Re: Formal Objection to Final Environmental Impact Statement and Draft Record of Decision for the Rosemont Copper Project – a Proposed Mining Operation within the Coronado National Forest

Project Name – Rosemont Copper Project: A Proposed Mining Operation
Responsible Official – Jim Upchurch, Forest Supervisor
National Forest, Ranger District – Coronado National Forest, Nogales Ranger District

Objection Figure 1
February, 2014

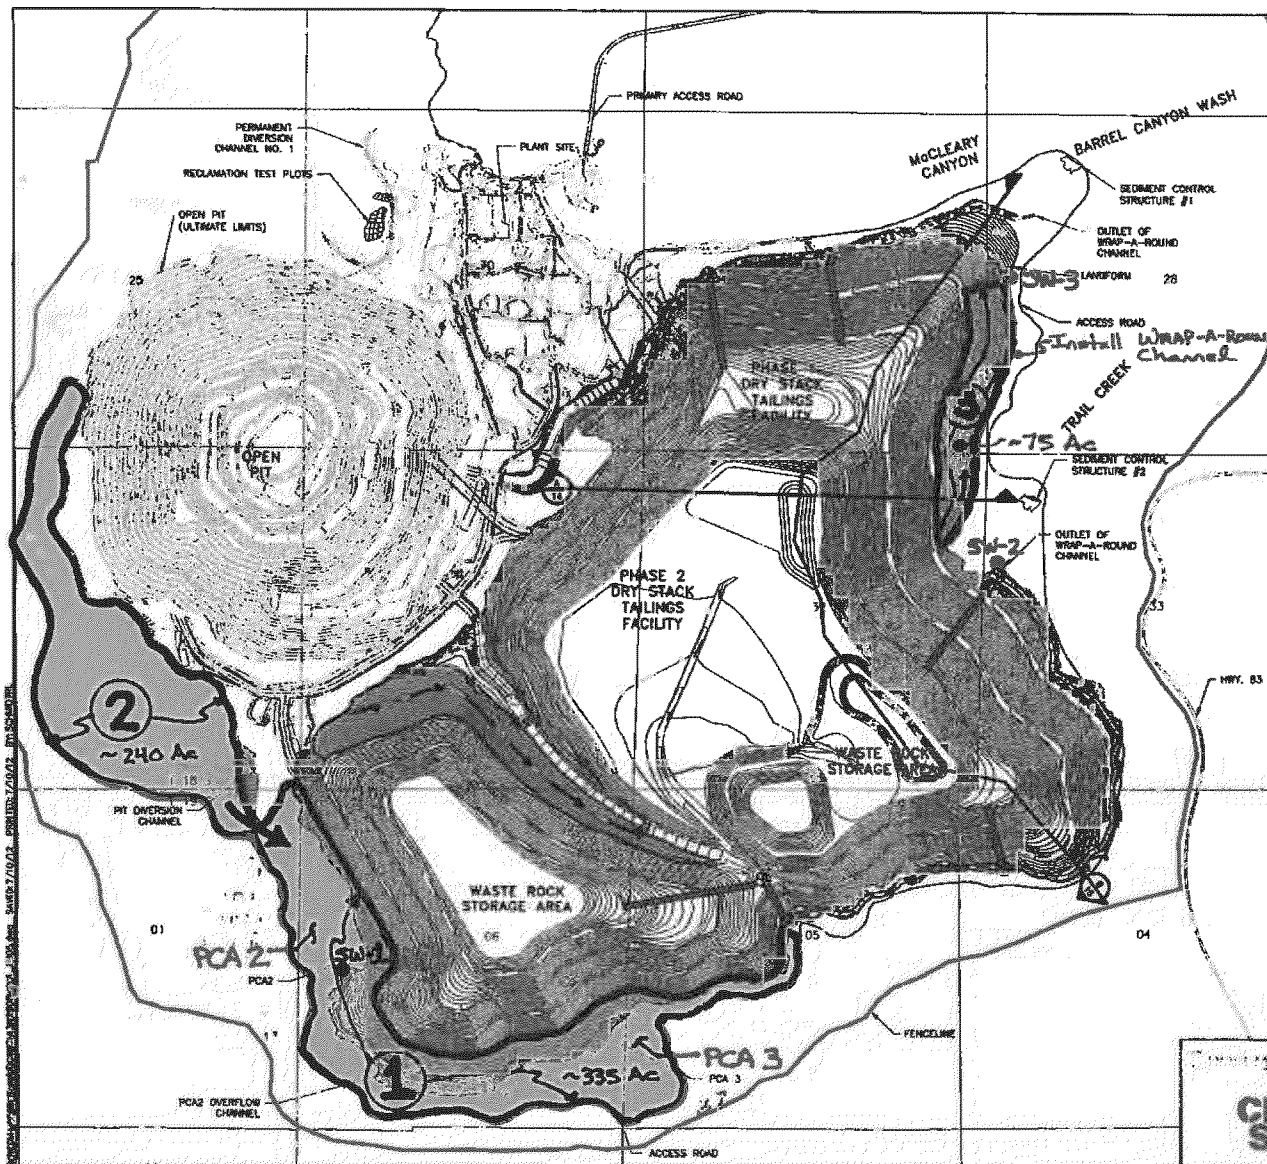
Objection Figure 1 (February 2014) is based on Figure 13 (Barrel Alternative Landform) of the CDM Smith *Preliminary Reclamation and Closure Plan* (July 2012). As shown on Objection Figure 1, stormwater which is intended to be collected and retained in PCA2 and PCA3 includes contributions from: the lower slopes of the Waste Rock mound and adjacent upper slopes of the Barrel Canyon watershed (Area 1), and the entire upgradient watershed area associated with the Pit Diversion Channel (Area 2). Area 1, comprising the area which is not planned for downstream drainage between the Waste Rock mound and the upper Barrel Canyon watershed divide, has a surface area of about 335 acres. Area 2, consisting of a mountainous watershed which sheds surface water to the Pit Diversion Channel for transfer into Area 1, has a surface area of about 240 acres with an approximate 100-yr discharge of 1800 cubic feet per second. Combined, Areas 1 and 2 have a watershed surface area approaching 1 square mile in size.

The Forest Service should require Rosemont Copper to professionally design and construct a stormwater management channel along the southern perimeter of the Waste Rock mound to collect and transmit surface waters from the Pit Diversion Channel (Area 2 on Objection Figure 1), and the lower side slopes of the Waste Rock mound and adjacent upper Barrel Canyon watershed (Area 1 on Objection Figure 1). The stormwater management channel would transfer these surface waters into the FEIS Wrap-A-Round channel alignment located at the east end of Area 1 (Objection Figure 1). From this point, the collected surface waters

There is sufficient grade for a continuous perimeter stormwater channel from PCA2 all the way around to the Trail Creek outlet at location SW-2. As shown on Objection Figure 1, the Waste Rock mound perimeter distance from Point SW-1 (elev ~ 5220 msl) to Point SW-2 (elev ~ 4820 msl) is about 20,000 ft, with a corresponding elevation drop of about 400ft. This corresponds to an average slope of approximately 2% for the perimeter system.

As shown on Objection Figure 1, there is no collection channel planned to transfer water collected at the base of the Area 3 sideslope interval. An additional wraparound or perimeter channel should be constructed at this location along the northeastern side of the Tailings mound. Instead, stormwater collecting from this approximate 75 acre watershed side slope simply ponds along the base of the sideslope, within three main tributary areas below the adjacent north-trending ridgeline. This situation is similar in nature to the trapped water in PCA 2 and PCA 3 as described above in Objection 1.

The Forest Service should require Rosemont Copper to professionally design, and construct, an approximate 5000 ft long stormwater management channel along the northeastern perimeter of the Tailings mound to collect surface waters from the lower eastern side slope (Area 3 on Objection Figure 1). Surface waters collected along the base of this slope should be routed to the tailings mound side slope stormwater channel shown at location SW-3, for transfer into the northern Wrap-A-Round channel and release in perpetuity at the channel outlet into downstream Barrel Canyon.
